ADDENDUM 2

project Lake Superior Zoo Black Bear Exhibit
project # 019001.00
date July 31, 2019
from Tiersa Wodash, DSGW Architects
to All planholders for above project

Sheet title: FIRST FLOOR
PLAN - POWER

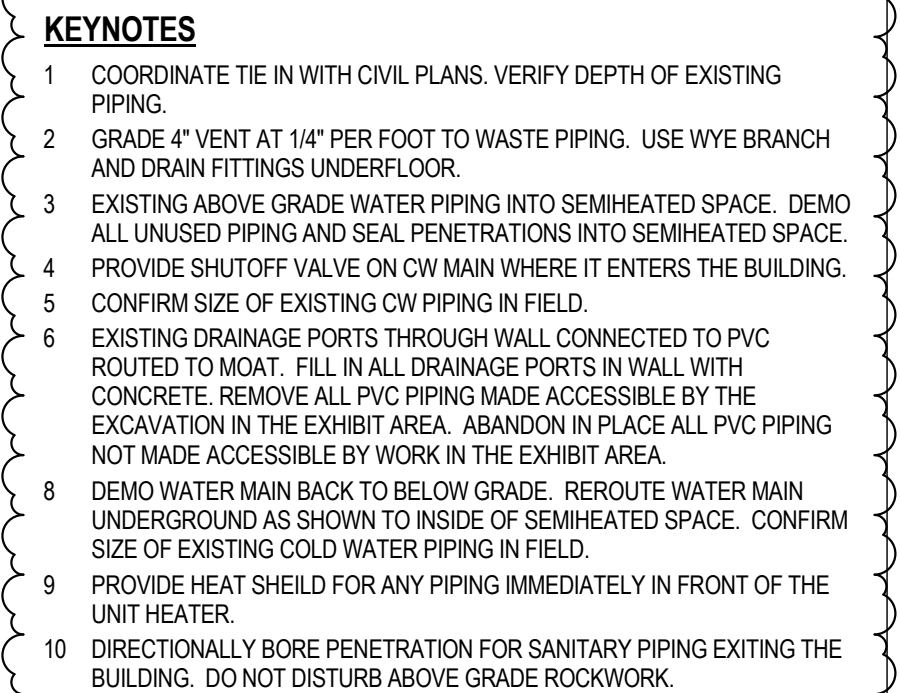
E2.1 FIRST FLOOR PLAN – POWER
1. Removed connections to heat trace.
2. Removed connection to recirculating pump.
3. Relocated connection to gas water heater.

PLUMBING SCHEDULES

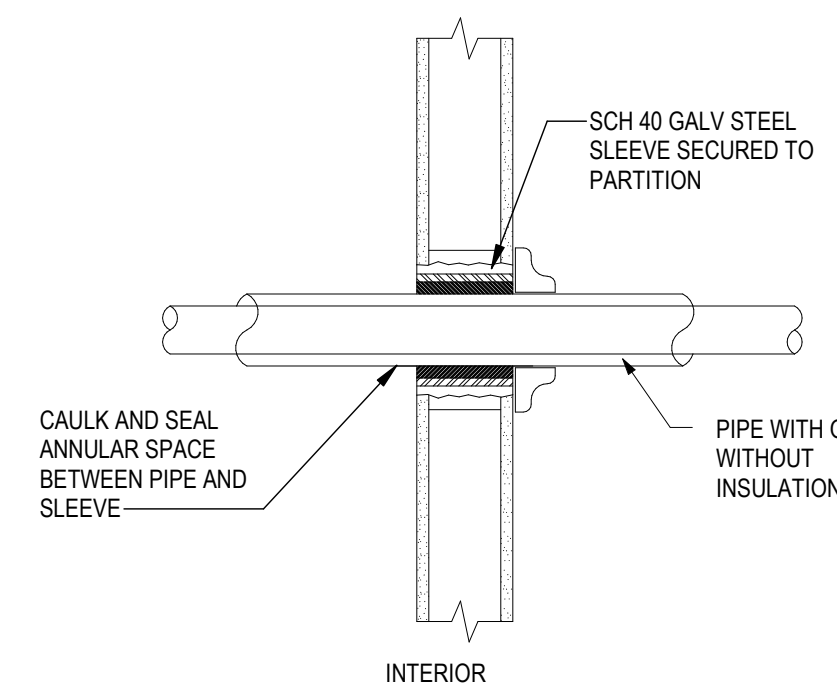
P5.1 PLUMBING SCHEDULES

1. Eliminated circulating pump schedule.
2. Revised Gas-Fired Water Heater Schedule.
